**CENTER FOR DRUG EVALUATION AND
RESEARCH**

IND 141802

MEETING MINUTES

MEMORANDUM OF MEETING MINUTES

Mean Serum Concentrations vs Nominal Times on Linear Scale of SB16 and USProlia(Pharmacokinetic Analysis Set, Study SB16-1001)

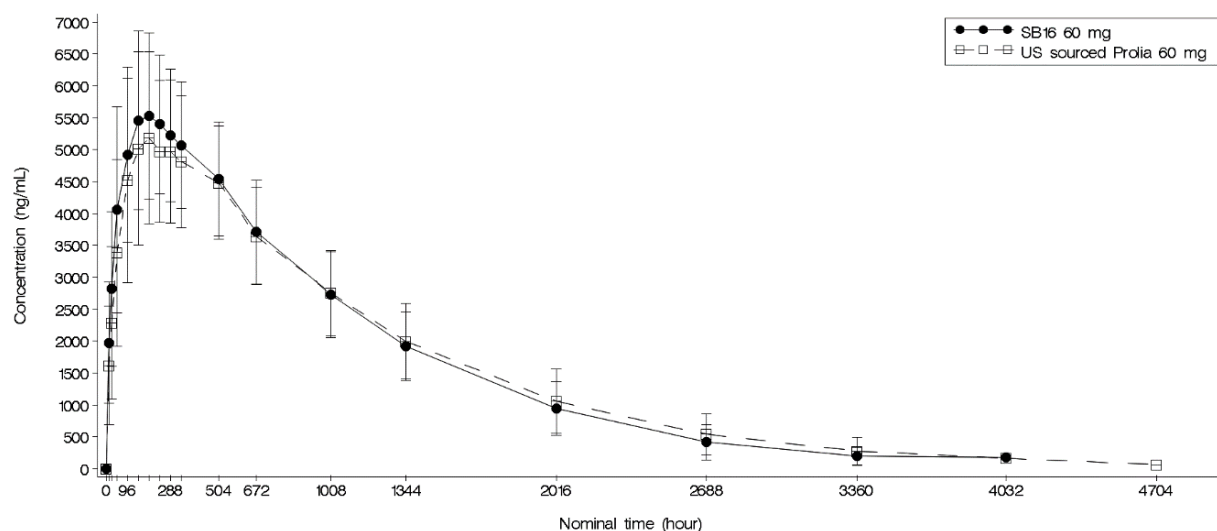
- We note that you applied a sampling duration of 28 weeks for pharmacokinetic analysis in Study SB16-1001. However, we previously recommended a sampling duration of 36 weeks for the PK similarity assessment in the Advice/Information Request letter dated March 14, 2022, since a significant number of subjects may not have a complete PK profile by week 28. You need to justify whether 28-week sampling period is sufficient to capture the complete PK profiles for subjects in Study SB16-1001.

Refer to slide 15/17 of Sponsor presentation for further explanation:

- *At Day 197 (EOS), all measured serum concentration of denosumab in the PK Analysis Set were below limit of quantification (BLQ), except 7 subjects with near BLQ level (i.e., 20 ng/mL).*

The Sponsor asked if FDA had any comments regarding their proposed justification. FDA replied that the justification for the 28-week PK sampling duration appears to be acceptable; however, a final decision will be made after reviewing the study data submitted to the BLA.
